# Technical Memorandum

**Project** Feather River West Levee

**Subject** Geotechnical Considerations for Landside Slopes of Segments 1 to 6  
for the Feather River West Levee Project

*Figure 1: Levee Section with Steep Slope in Lower Half of the Levee*

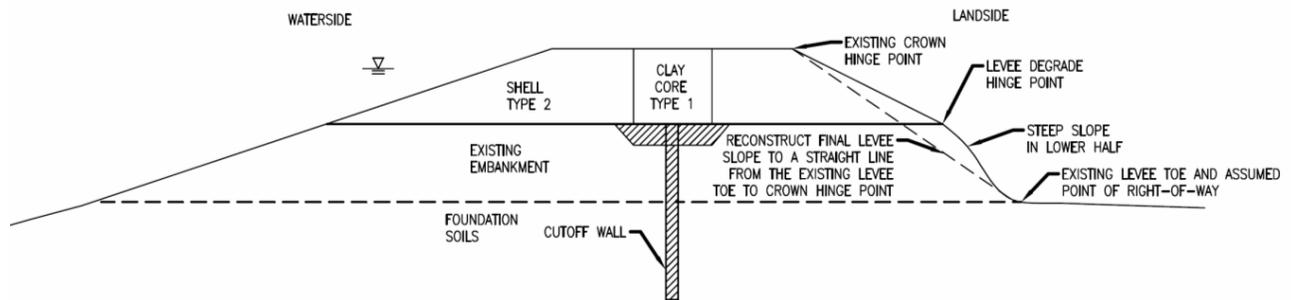
2. In some areas, there are slopes that have localized steeper portions in either the upper or lower portion of the slope (Figure 1 and Figure 2). That is, the slopes have a slightly concave or convex profile. The current proposal of only re-grading the portion of the slope above the degrade elevation would leave many of these localized steeper portions in place. These slopes have the potential for localized stability problems during construction and in the longer term.
